HPC / PLANNING REVISION

WASHINGTON SQUARE CONVENIENCE STATION

## Memorandum

RE: Washington Square Restroom Replacement

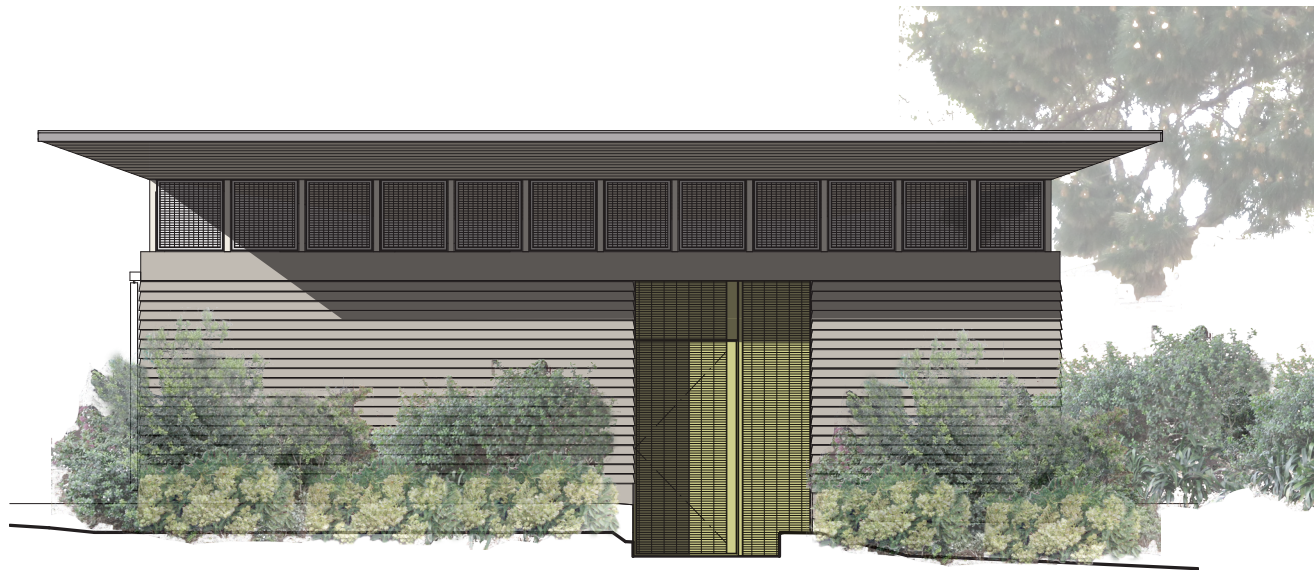
In your email you relayed to us that after careful consideration and consultation with your Commission, it is the Planning Department's position that the recess over the primary restroom entrance is needed to break up the massing of the building, a key factor in determining the design's appropriateness in the context of the landmark site. You informed us that should we wish to pursue making this change to the park-facing building façade, staff would require that we investigate alternative methods to reduce the building mass. You further wrote that the removal of the recess over the maintenance door was found to be a minor change to the project, and that you felt that removal of the recess at that entrance would be in keeping with the intent of the HPC approval.

Attached please find a copy of the final design for the project. As you will see, the final project design has retained the recess over the primary entrance to the restrooms and removed the recess over the maintenance door.
